Application No. 10/791,042

Response to Non-Final Office Action of June 25, 2007

Amendments to the Drawings:

Fig. 4

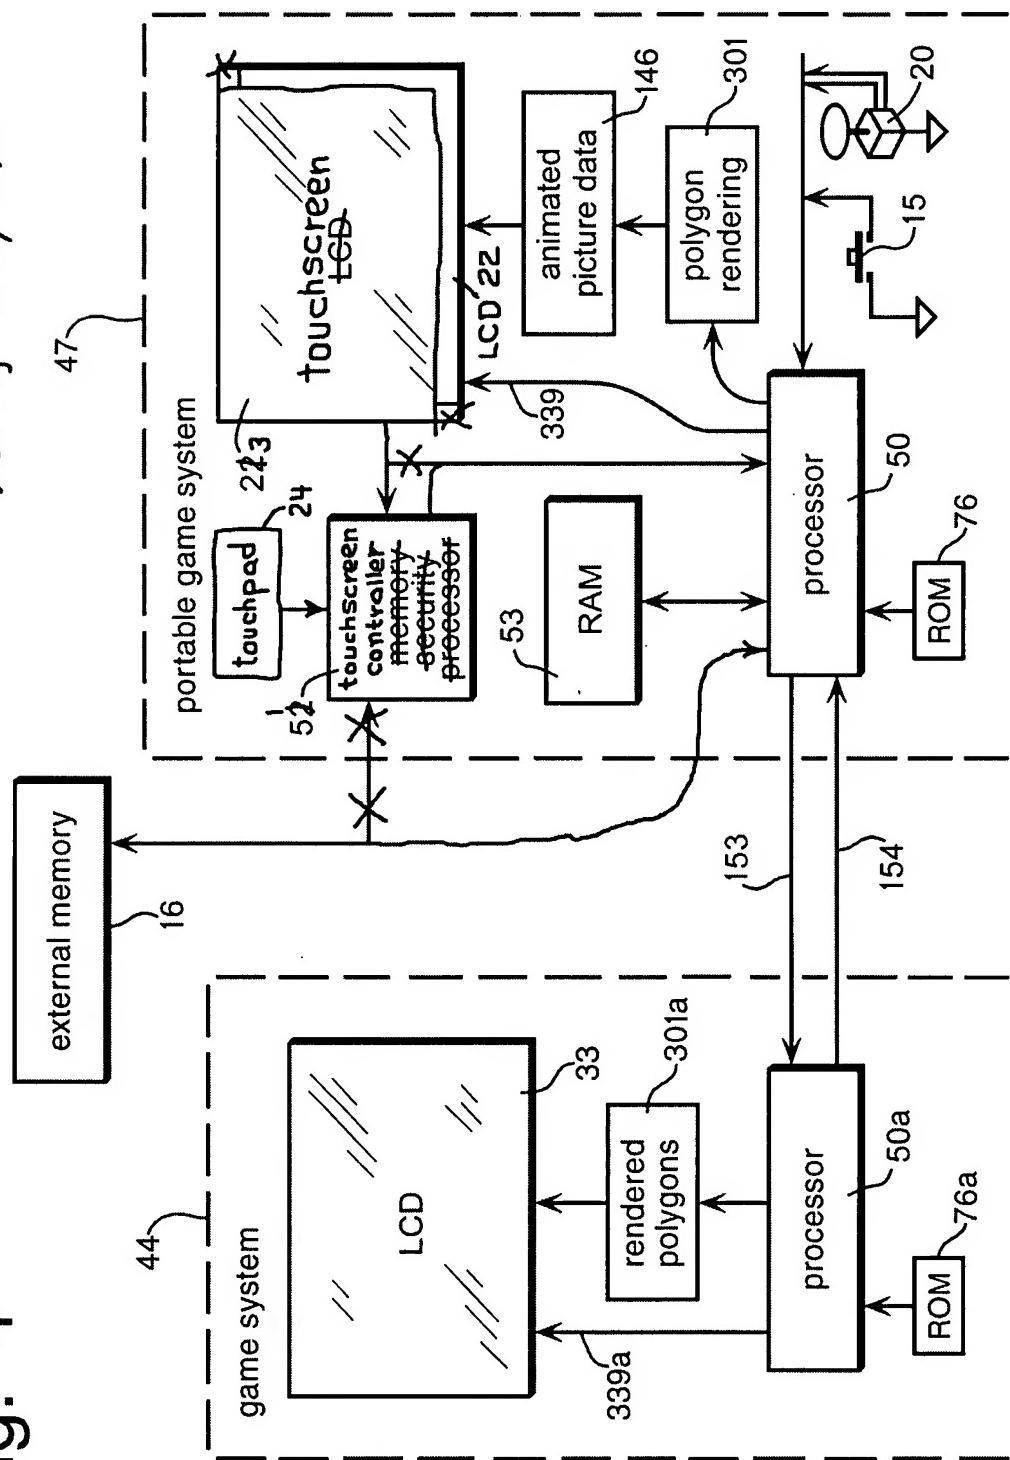
Sheet 4 (Fig. 4) is amended to show touchscreen 23 on LCD 22, touchpad 24, and touchscreen controller 51 which find support in Fig. 4 of parent application 09/928,294.

Replacement Sheet 4 (Fig. 4) is submitted herewith to show touchscreen 23 on LCD 22 that was fully disclosed with reference to Fig. 4 in parent application 09/928,294, but was mistakenly omitted in Fig. 4 of the present application.

amended material
from Fig. 4 in 09/928,294

Fig. 7

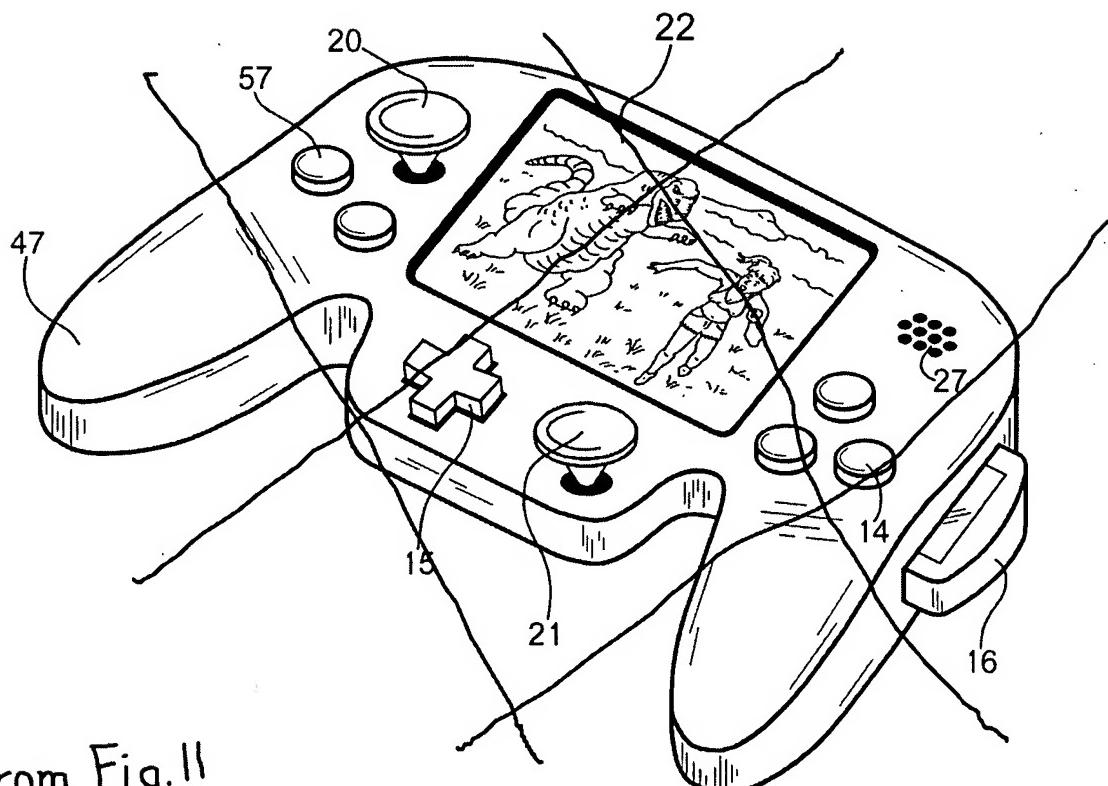
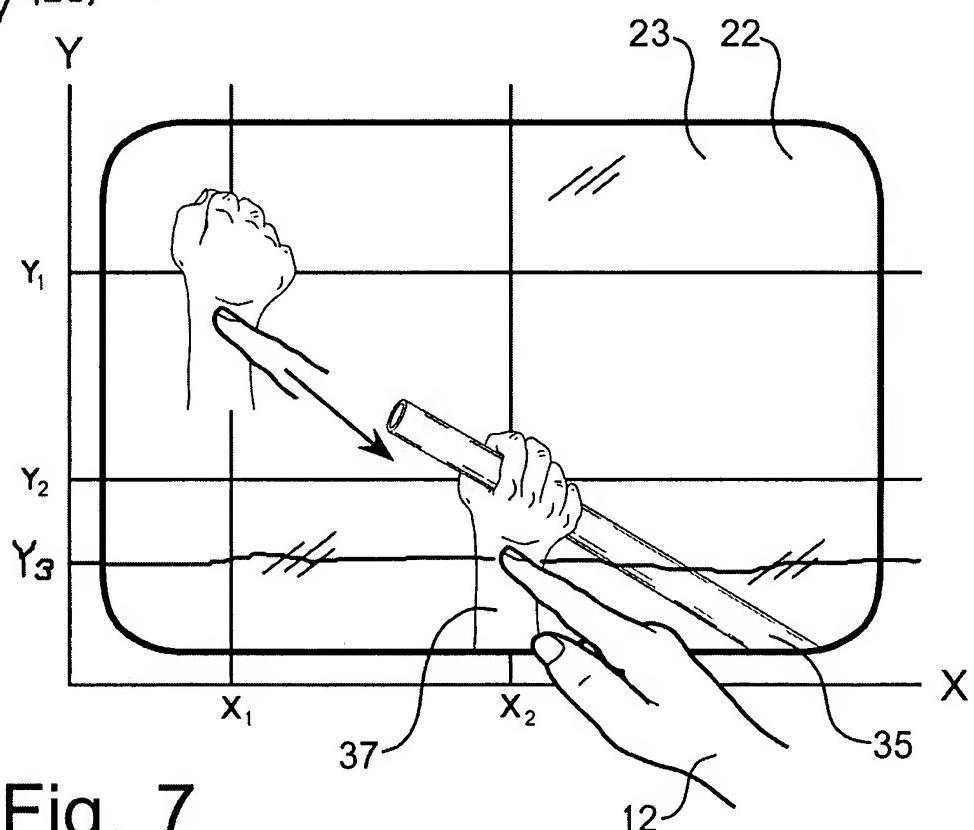
Sheet 7 (Fig. 7) is replaced by Fig. 11 from parent application 09/928,294 and amended to provide a reference code Y₃ for the horizontal coordinate on which finger 12 touches touchscreen 23.

Replacement Sheet 7 (Fig. 7) is submitted herewith to replace the previous Fig. 7 and to provide a reference code Y₃ for the horizontal coordinate where finger 12 touches touchscreen 23. Replacement Fig. 7 is from Fig. 11 in parent application 09/928,294.

from Fig. 11
in 09/928,294
